**STAFF RECOMMENDATION**

**714 Shelby Avenue**

**July 19, 2017**

**Description of Project:** Construction of a new two-family building on a vacant lot.

Figure 1. 714 Shelby Avenue

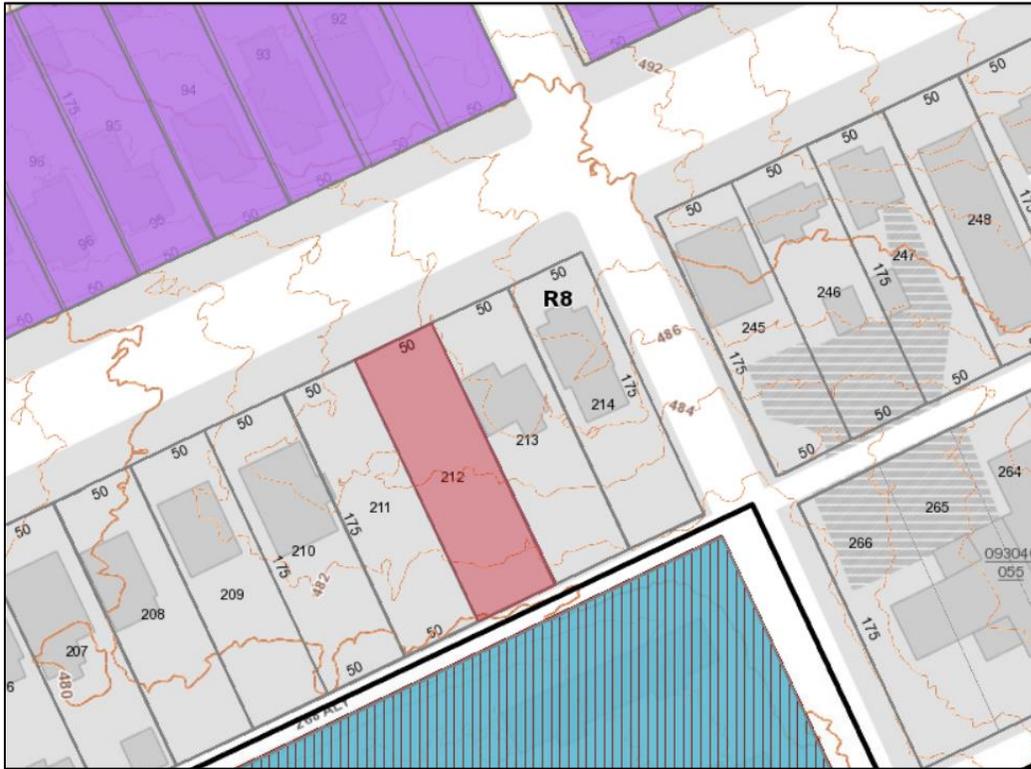
**Background:** This vacant lot is located at 714 Shelby Avenue (Figure 1). Previous versions of infill on this lot were denied by the MHZC. The applicant proposes a new design.

ELEVATIONS

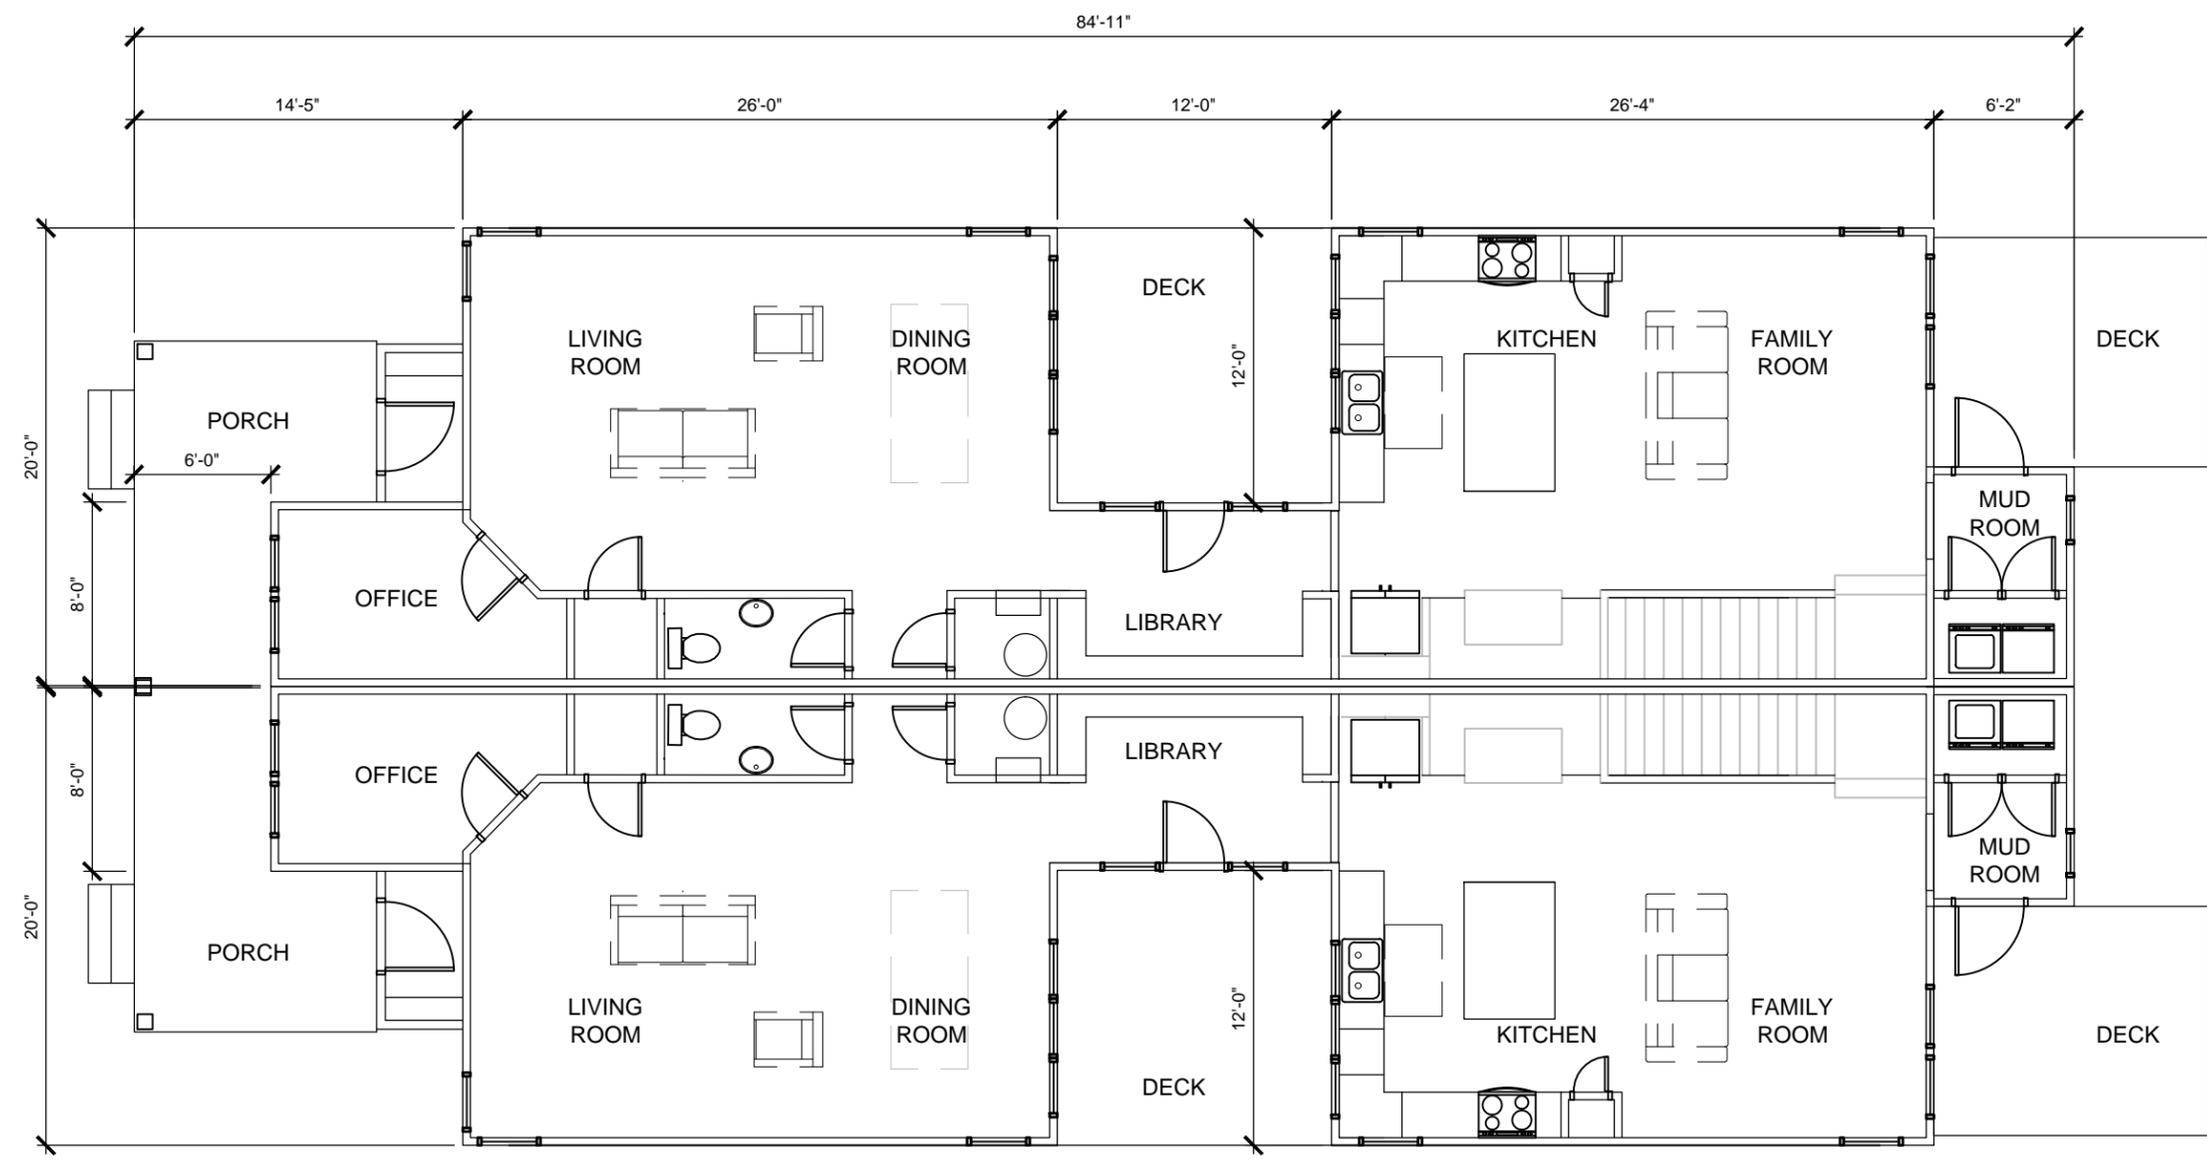
**Height & Scale:** The new building is one and a half stories with an average height of twenty-seven feet (27') from grade at the front. There is a slight grade drop to the rear. The range of building heights on the block face is from eighteen to twenty-eight feet (18'-28'). The foundation height is drawn as two blocks tall. The foundation height nearby is from two to four blocks, so the foundation is compatible. Staff recommends as a condition of approval that the height of the foundation and floor systems shall be verified to ensure that the finished floor level of the new construction is compatible with the historic context. The eave height is eleven feet, six inches (11'6") which is compatible with neighboring buildings which have eave heights from ten to twelve feet (10'-12'). The building is thirty-nine feet (39') wide, on a fifty foot (50') wide lot. This is within the range of building widths nearby, which are from twenty-five to forty feet (25'-40'). Staff finds that the massing and scale is similar to historic buildings in the neighborhood; therefore, staff finds the project meets section III.B.2.b. and III.B.2.c. of the design guidelines.

Building and Roof Shape: The building has a side-gabled form with a projecting central bay with each unit's porch at the front of the bay. The primary roof pitch is 10/12. Between the side-gabled sections the house narrows and a twelve foot (12') section of the second story projects by one foot, four inches (1'4") over the first story on each side. This cantilevered feature is not typical of historical forms, but as this section of the house will be hidden from view behind the gabled part in front of it, Staff finds it appropriate in this case. Staff finds that the application meets section III.B.2.c and III.B.2.d.

Proportion and Rhythm of Openings: The windows on the house are generally twice as tall as they are wide, meeting the historic proportion of window openings. There are no large expanses of wall space without a window or door opening. Staff recommends that all double and triple window sets have a four to six inch (4"-6") mullion in between them. With four to six inch (4"-6") mullions on all paired and triple window openings, staff finds the project's proportion and rhythm of openings to meet Section III.B.2.f. of the design guidelines.

1. The front setback matches the recently-approved infill next door;
2. The finished floor height shall be consistent with the finished floor heights of the adjacent historic houses, to be verified by MHZC staff in the field;
3. Double and triple windows have a four to six inch (4"-6") mullion between them;
4. Staff approve the roofing color, porch columns, windows and doors prior to purchase and installation; and,
5. The HVAC shall be located behind the house or on either side, beyond the midpoint of the house.
